MTC -  
SPRINGDALE  
HALL  
RESTROOM -  
AIRPORT  
CAMPUS  
H59-N241-CL

DESCRIPTION  
APPENDIX ONE

HVAC FLOOR PLAN,  
SCHEDULES AND  
DETAILS

**M101**

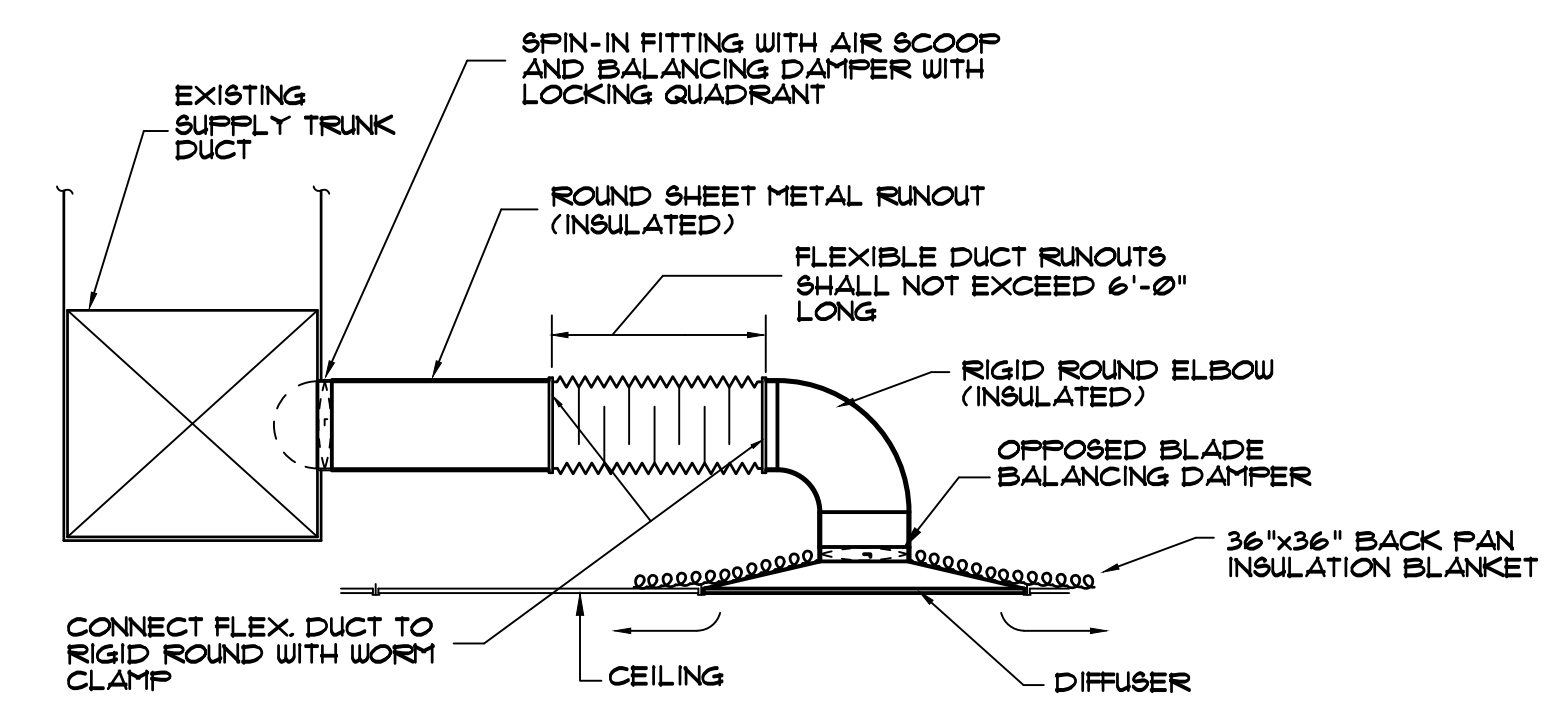
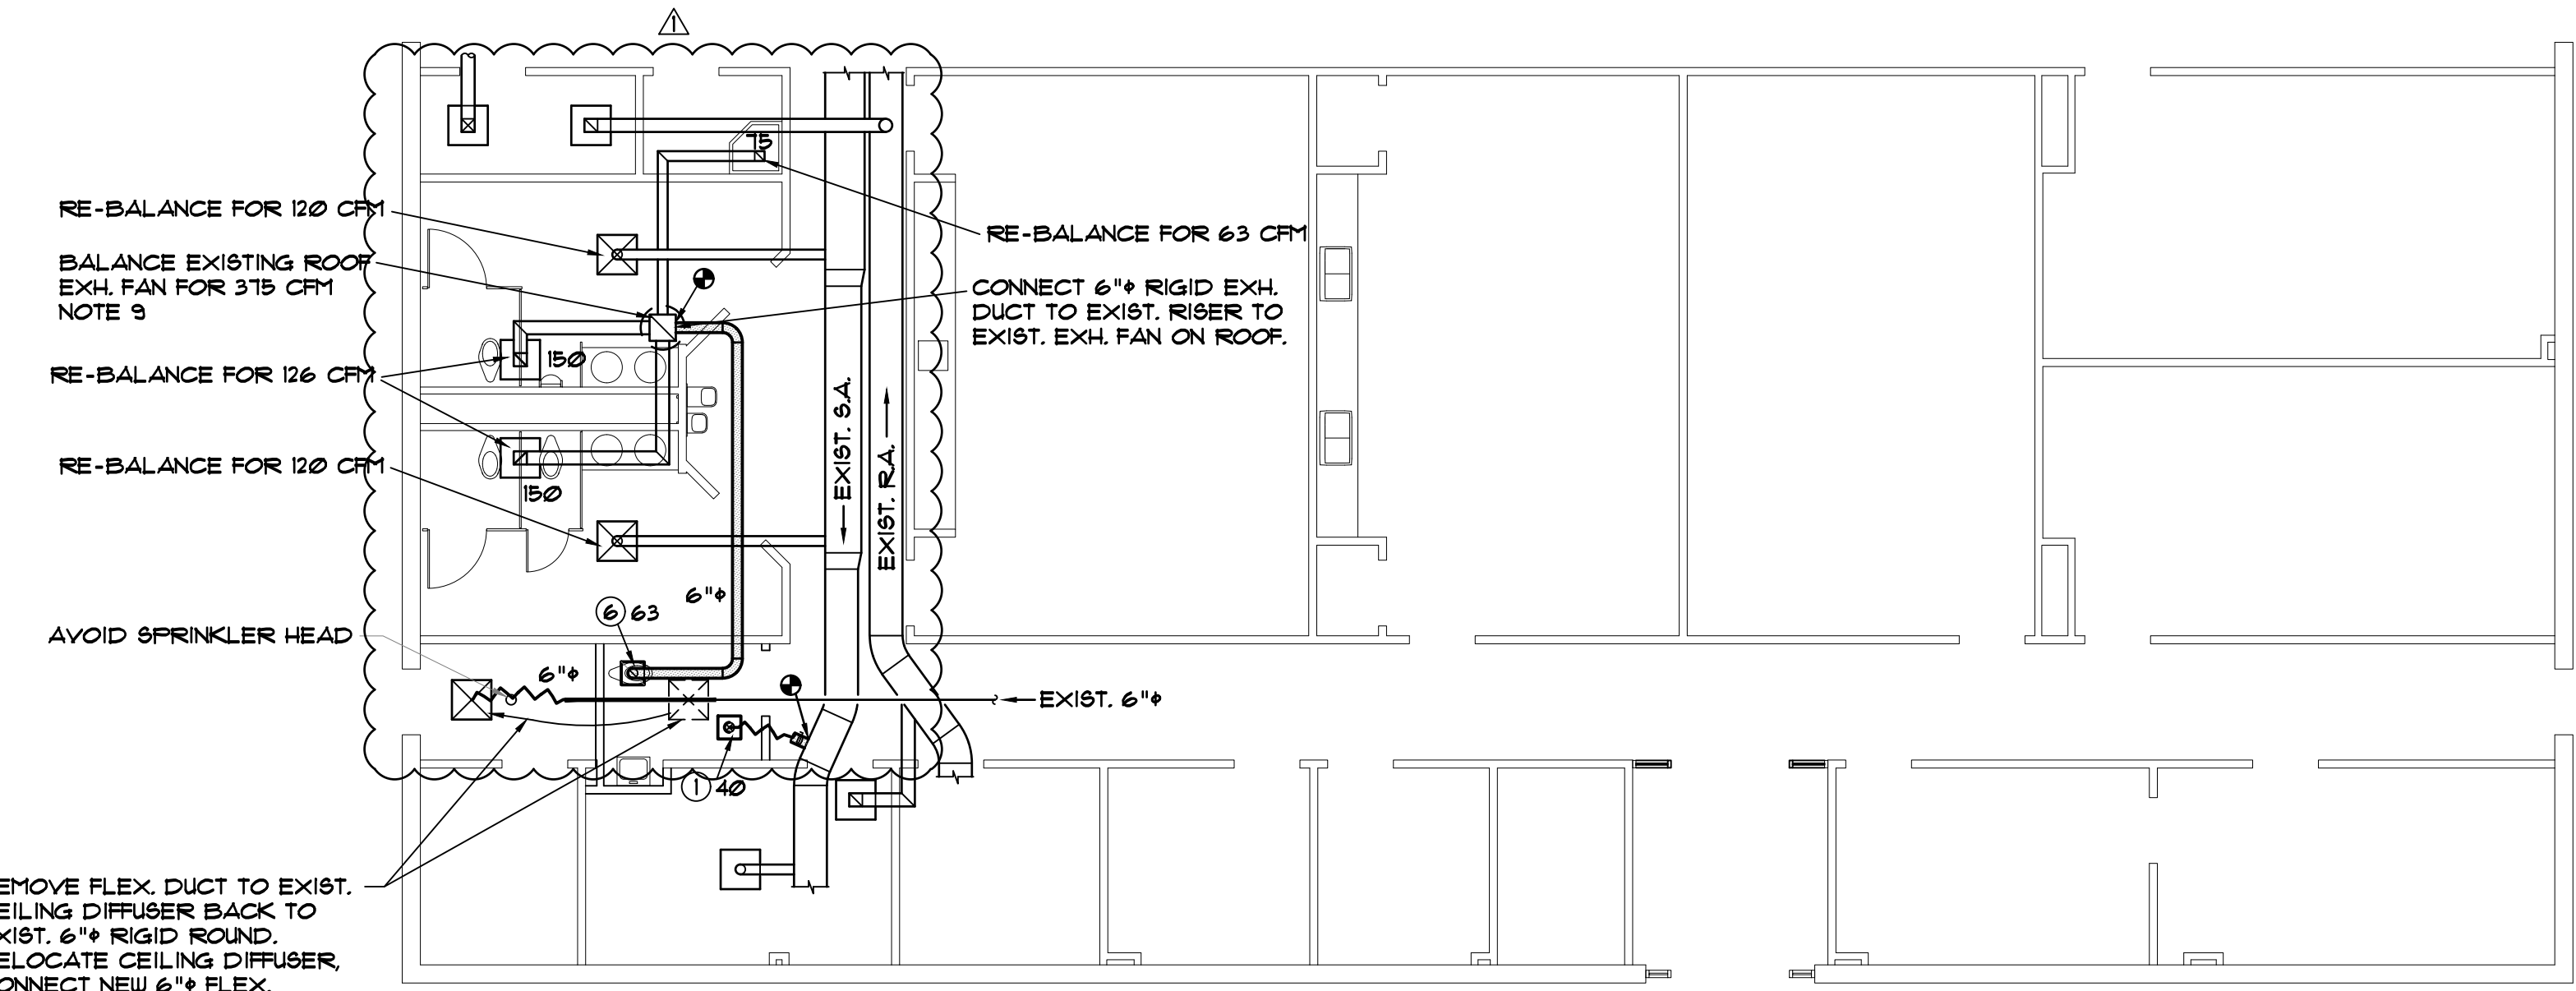
DELETED FAN SCHEDULE  
DELETE FANS FROM SUBMITTAL REQUIREMENTS
